Subject: MHI's Supplemental Responses to US-APWR DCD RAI No. 659-5133 (SRP 03.07.01)

Supplemental Responses to Request for Additional Information
No. 659-5133, Revision 2

RAI NO.: NO. 659-5133 REVISION 2
SRP SECTION: 03.07.01 – Seismic Design Parameters
APPLICATION SECTION: 3.7.1
DATE OF RAI ISSUE: 11/15/10

QUESTION NO. RAI 03.07.01-17:

Figure 6. Strain-compatible damping developed for profile 270m/sec and 500 ft depth.

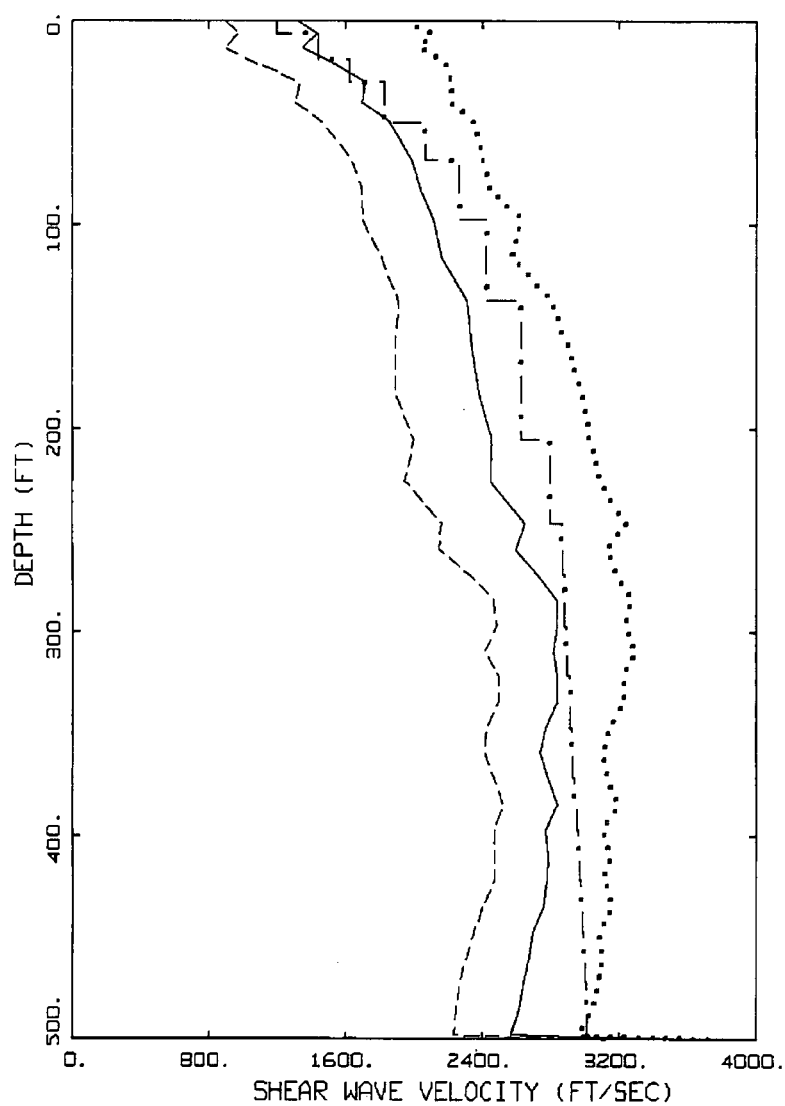
On the February 7, 2011 US-APWR NRC Weekly DCD Chapter 3 conference call, the NRC requested the following additional information: (1) description and justification of a decrease in shear wave velocity with increase in depth, as observed for some of the standard plant profiles whose strain-compatible properties are presented in Section 5.2.2 of MHI Technical Report MUAP-10001, and (2) provide copy of the referenced unpublished curves in Part 3 of 5 of the original response for the NRC staff's review.

The 270-500 profile shows a similar but much more subdued trend, as illustrated in Figure 4 for the shear-wave velocities (see also Table 5.2-5 in MUAP-10001). In Figure 4, the shear-wave velocities just above 500 ft show a light decrease resulting from the increase in cyclic shear strains at the same depth, illustrated in Figure 5. The corresponding increase in shear-wave damping is shown in Figure 6.

Figure 7. Rock modulus reduction and hysteretic damping curves developed for rock site conditions.

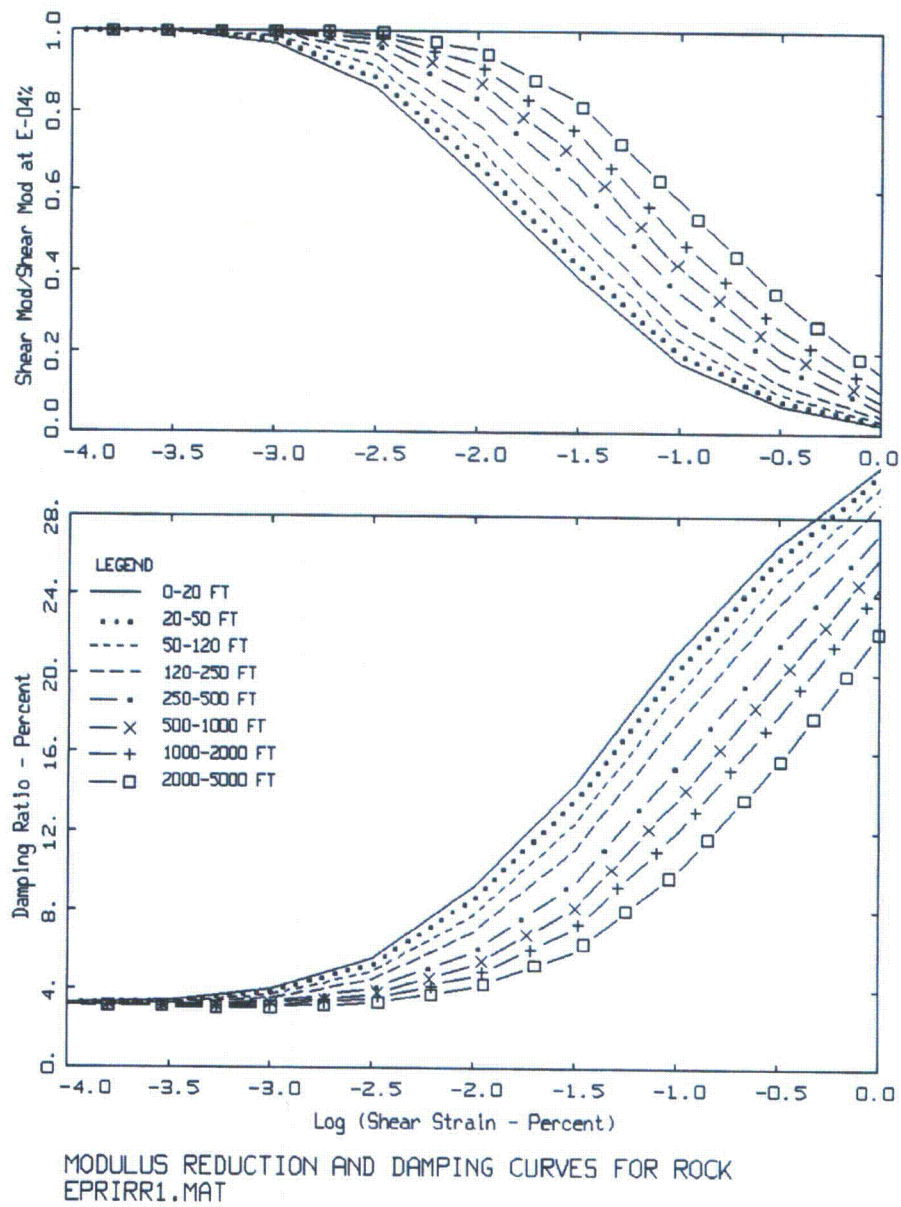
(2) Provide Unpublished Curves Referenced in Part 3 of 5 of initial response

The response to item (3) in the original RAI stated that an unpublished suite of modulus reduction and hysteretic damping curves appropriate for soft and firm rock conditions were used for development of the horizontal component site response analyses. The rock curves were developed during the EPRI project (refer to TR-102293) assuming soft and firm rock exhibits a nonlinear dynamic material behavior similar to gravels. The rock curves were not included in TR-102293 as the final suite of amplification factors was based on soil profiles intended to capture the behavior of soils ranging from gravels to low plasticity sandy clays at CENA nuclear power plants. Those curves are presented and explained as follows.

The curves used for the soft and firm rock sites (560m/sec and 900m/sec), which are shown in Figure 7 below and also shown in Figure 4.2-2 of MUAP-10001, were an outgrowth of the EPRI Ground Motion Study (EPRI, 1993), which, amongst many other things, included development of the depth dependent generic modulus reduction and damping curves for sandy materials that are shown in Figure 8 below. The "rock" curves are not shown in Appendix 7A of the EPRI (1993) report, which details the development of the "sand" curves, but are based on the range suggested for modulus reduction and damping of gravels. The general positioning of the "sand" and "gravel" curves has subsequently been confirmed by the work of Darendeli (2001) and Menq (2003) at the University of Texas. Formal development of modulus reduction and damping curves for "rock" is difficult because not only does this designation cover a wide range of materials but all these material are effectively impossible to sample and test in the laboratory and attempts to determine modulus reduction and damping from field measurements are still in their infancy. At shallow depths, however, say less than 200-300 feet, rock-like materials are often weathered and almost invariably fractured. Weathering and fractures affect the properties of the rock-like materials such that it is not unreasonable to assume modulus reduction and damping curves that are similar to those for gravels, since it is now well established that material behavior becomes more nonlinear as the particle size increases – as one goes from clays to sands to gravels and rock mass. The sensitivity of the results of site response analyses to the selection of modulus reduction and damping curves for rock-like material is in any case limited by the fact that they generally have higher stiffnesses and thus develop lower shear strains than do soil-like materials for the same level of loading. At much greater depths, where weathering is absent and fractures are likely to remain closed, even under strong shaking, the behavior of rock-like materials can safely be assumed to remain largely elastic so that modulus reduction and damping curves may no longer be applicable. It should be pointed out that the increase in velocity with depth at the rock profiles (560m/sec and 900m/sec) is such that for depths exceeding several hundred feet the shear-wave velocities exceed about 2,500 ft/sec, resulting in relatively low strains at the moderate loading levels associated with the 0.3g zero period acceleration of the CSDRS. For example, the soft rock 560m/sec profile has a shear-wave velocity of about 2,900 ft/sec (883m/sec) at a depth of about 300 ft (91m). At a 0.3g loading level the corresponding peak cyclic shear strains are about 0.012% with a strain-compatible velocity of about 2,800 ft/sec, reflecting a modest reduction of about 4%.
